STAFF RECOMMENDATION
3726 Richland Avenue
November 18, 2015

Application: New construction--addition
District: Richland-West End Neighborhood Conservation Zoning Overlay
Council District: 24
Map and Parcel Number: 10409007300
Applicant: Stephen Wells, Wells Design Associates
Project Lead: Paul Hoffman, paul.hoffman@nashville.gov

<p>Description of Project: Construction of a rear addition to a contributing home.</p> <p>Recommendation Summary: Staff recommends approval with the conditions:</p> <ol style="list-style-type: none">1. Staff approve the final details, dimensions and materials of windows and doors prior to purchase and installation; and,2. The HVAC shall be located behind the house or on either side, beyond the mid-point of the house; and3. Staff approve the roof color and masonry color, dimensions and texture. <p>With these conditions, the project meets the design guidelines for the Richland-West End Neighborhood Conservation Zoning Overlay.</p>	<p>Attachments A: Photographs B: Site Plan C: Elevations</p>
--	--

1 SITE PLAN
 full-size: 1/8"=1'-0"
 half-size: 1/16"=1'-0"

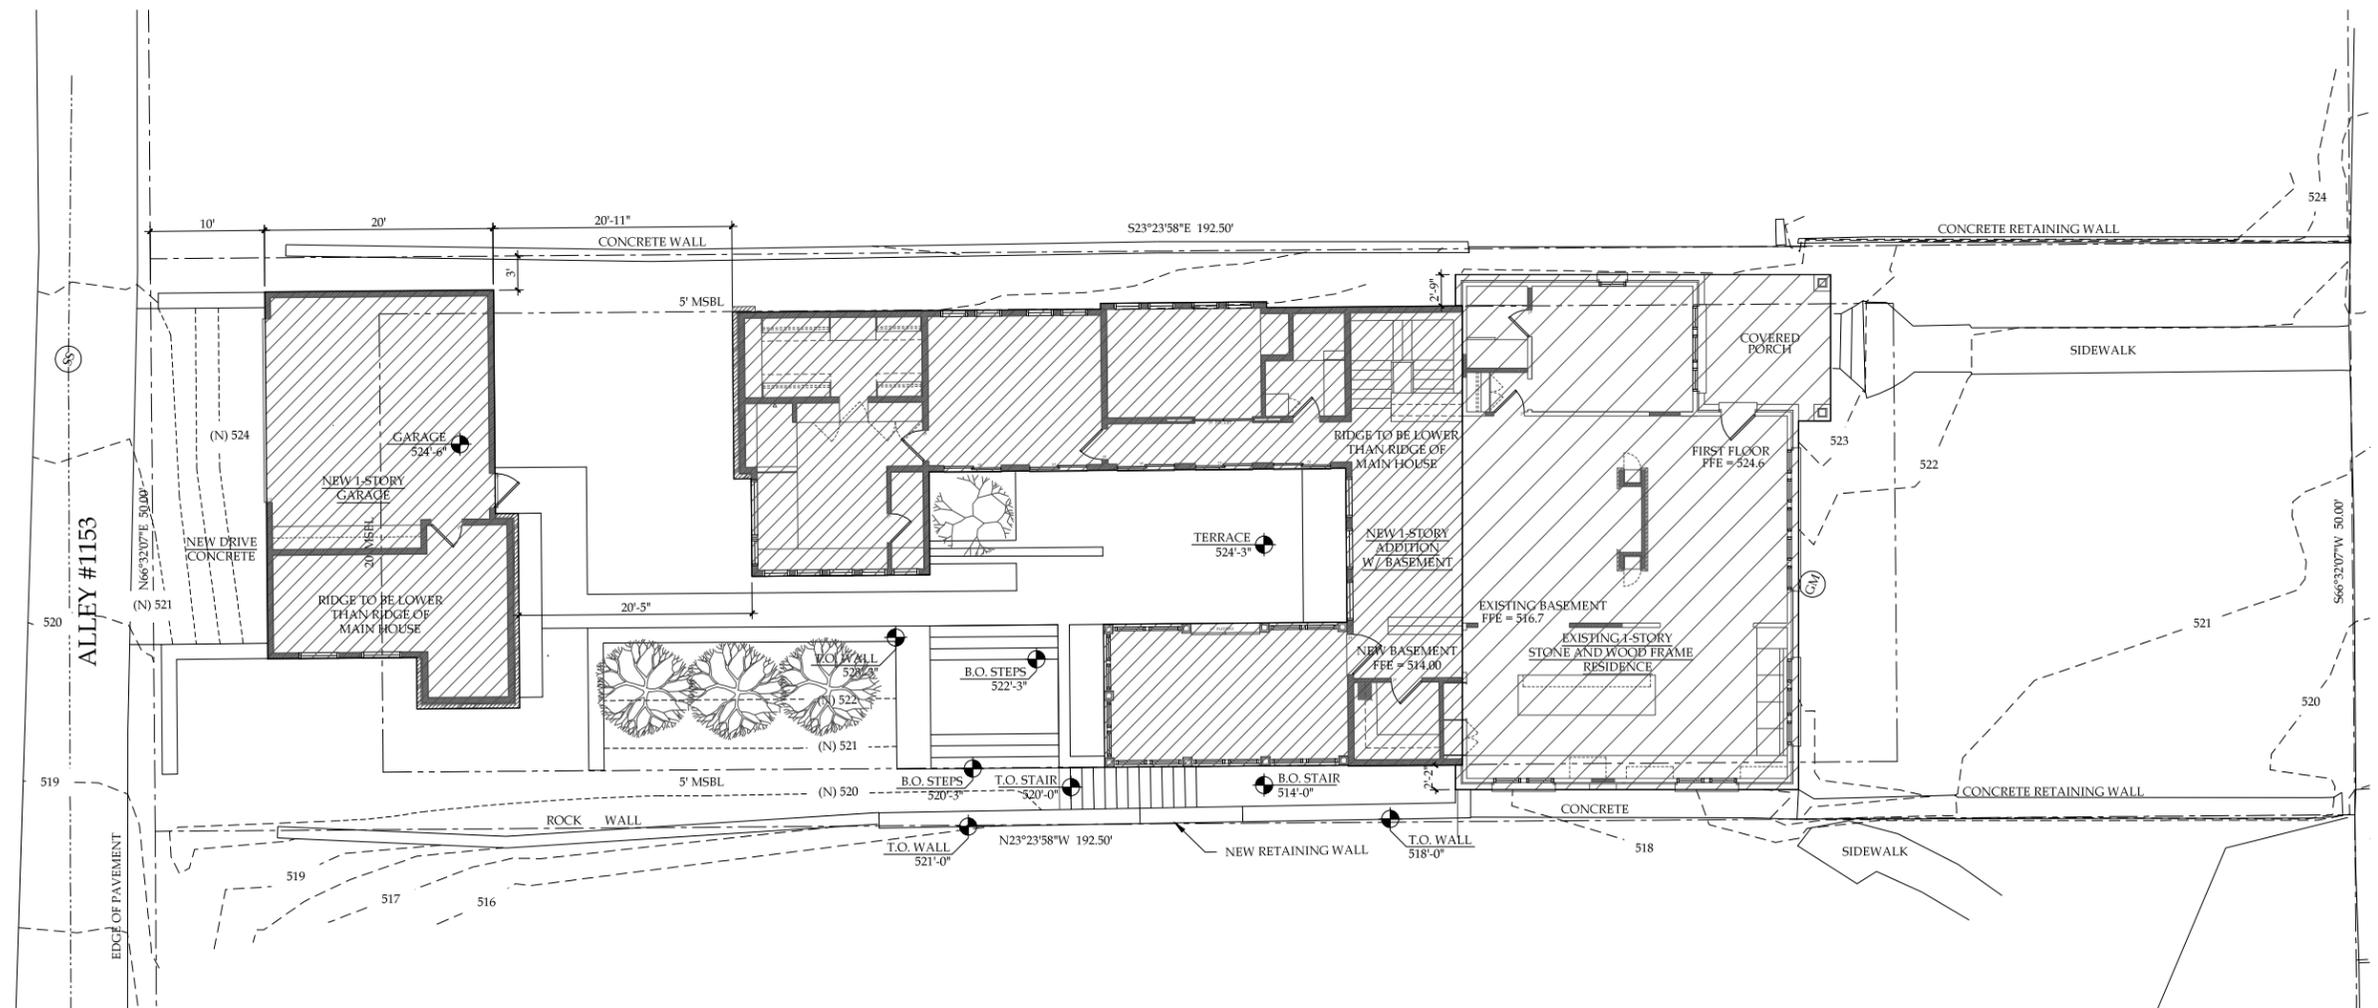
Setback: The setbacks will be five feet (5') on the sides. The rear setback will be approximately fifty feet (50') feet. The project meets the base setback requirements of five feet (5') on the sides and twenty feet (20') at the rear. It meets section II.B.1.c of the design guidelines for setback.

2 WEST ELEVATION: LEFT
 full-size: 1/4"=1'-0"
 half-size: 1/8"=1'-0"

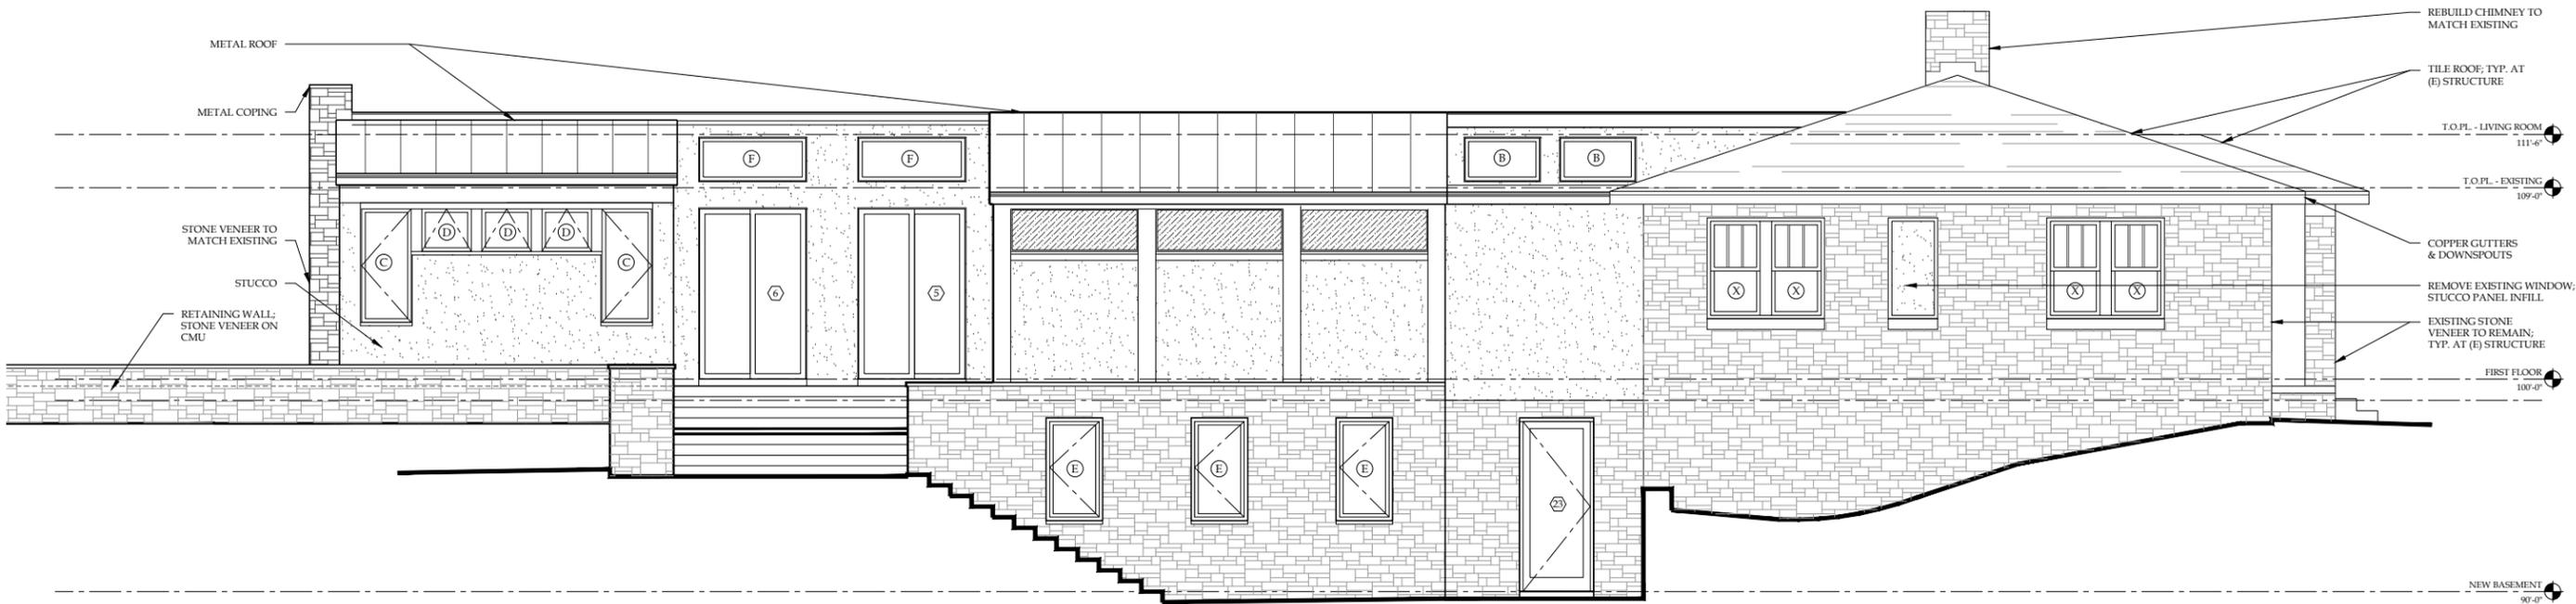
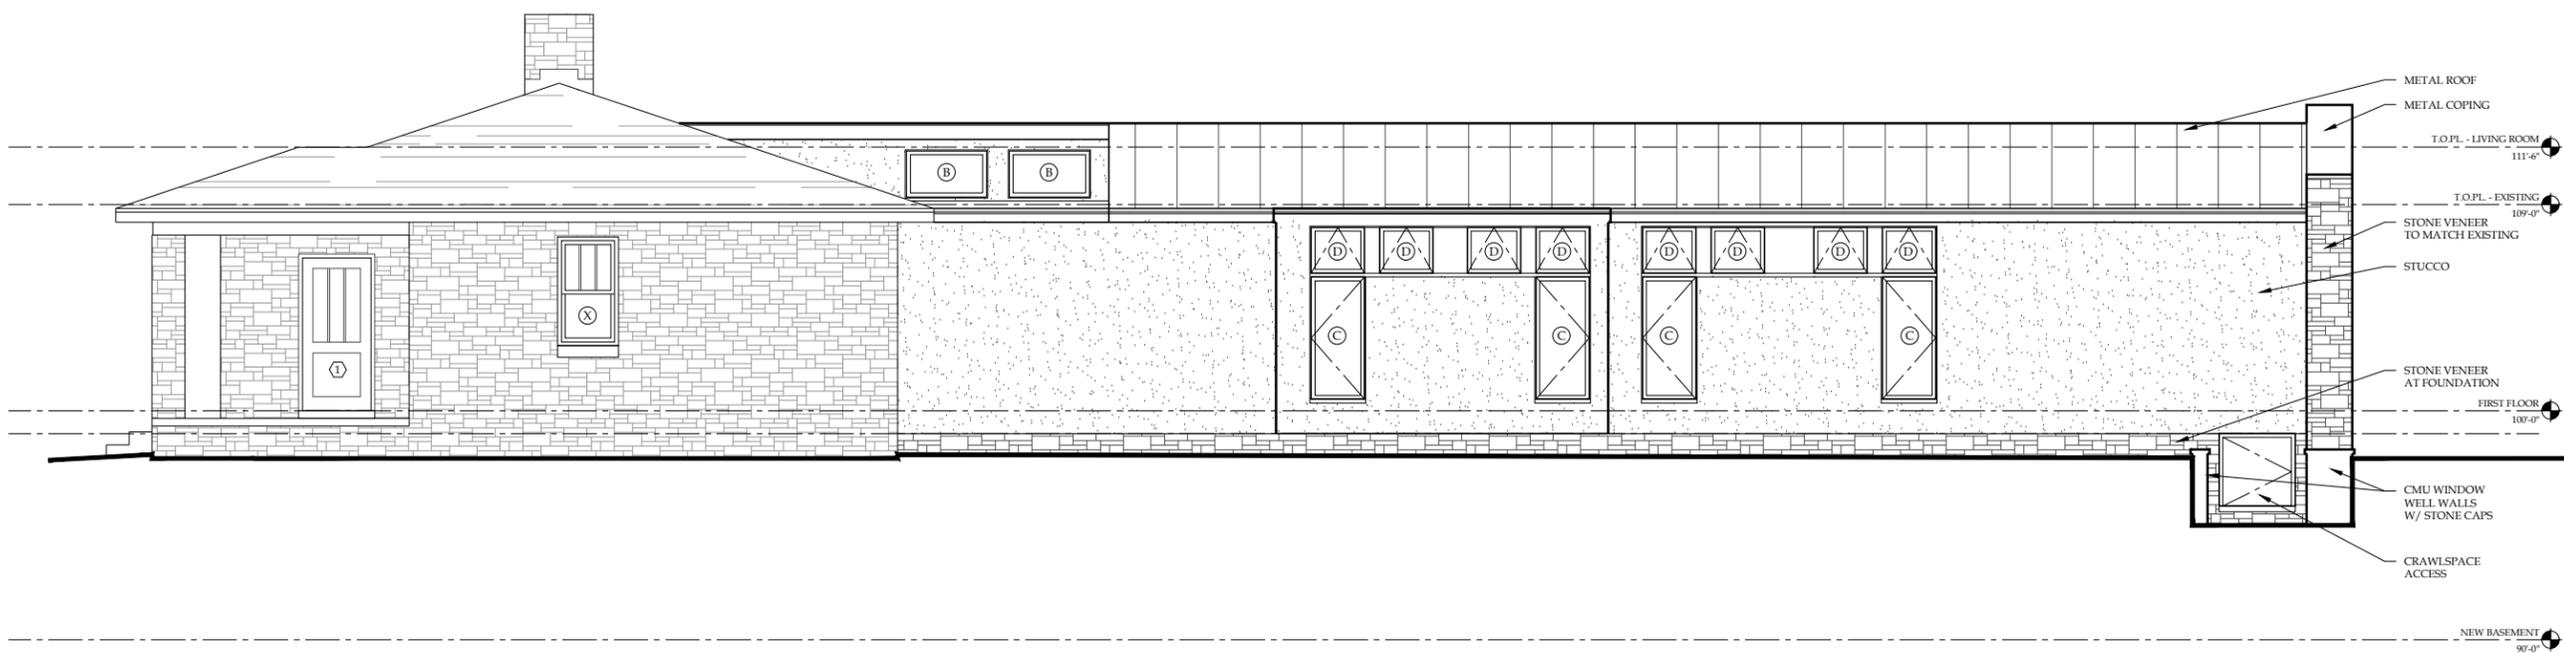
Demolition: The project includes the removal of most of the existing rear wall of the house. One window on the left side of the existing house is proposed to be filled in with a stucco panel. The window will be removed, but the opening itself will remain. The location is past the midpoint of the house. Staff finds that filling in the window opening, and the removal of the rear portions will not be detrimental to the architectural or historical integrity of the structure. The proposed demolition meets Section III.B.2 for appropriate demolition and does not meet section III.B.1 for inappropriate demolition.

Height & Scale: The addition primarily consists of two wings. A screened porch adds twenty-one feet (21') on the left side and the main addition extends sixty-four feet (64') back. This is longer than the house itself, but Staff finds the length of it to be permissible for several reasons. The addition will be broken up into two sections, and will be two feet (2') lower than the existing ridge height of the house. The total added footprint will be one thousand, two hundred and ninety-four square feet (1,294 sq. ft.), which is less than the footprint of the house and the homes are close together on this side of the house making the addition minimally visible. The eave height and foundation height will match those of the house. The project meets section II.B.1.a and b.

Materials: The addition will have stucco cladding. The foundation, as well as the rear wall of the right-side addition will be a stone veneer to match the existing stone on the house. The roof will be metal on the ells, and a membrane material on the central section. The retaining wall will have stone veneer over concrete block. Materials for the screened porch were not specified. With the staff's final approval of the masonry, roofing color, windows and doors, staff finds that the materials meet section II.B.1.d and II.B.2.e.

Roof form: The central section of the addition will have a low-sloped roof over a clerestory. The side ells will have a pitch matching the existing pitch of the house on each side, approximately 4/12. The addition's roof form is unusual, but Staff finds that it will be visually compatible with the house. The project meets section II.B.1.e.

Proportion and Rhythm of Openings: The addition's fenestration is contemporary. It features windows that are traditionally-proportioned, square windows, and transoms. Although the window pattern is not typical of historic structures, the fenestration is a considered element of the overall design. The horizontal windows are typical of a

clerestory, and those toward the rear of the left side can be read as transoms to the doors beneath them, which the Commission has approved previously. The rhythm of solids to voids does not contrast greatly with surrounding historic buildings. Staff finds the addition's proportion and rhythm of openings to meet Section II.B.1.g.

1. Staff approve the windows and doors prior to purchase and installation;
2. The HVAC shall be located behind the house or on either side, beyond the mid-point of the house; and
3. Staff approve the roof color and masonry color, dimensions and texture.
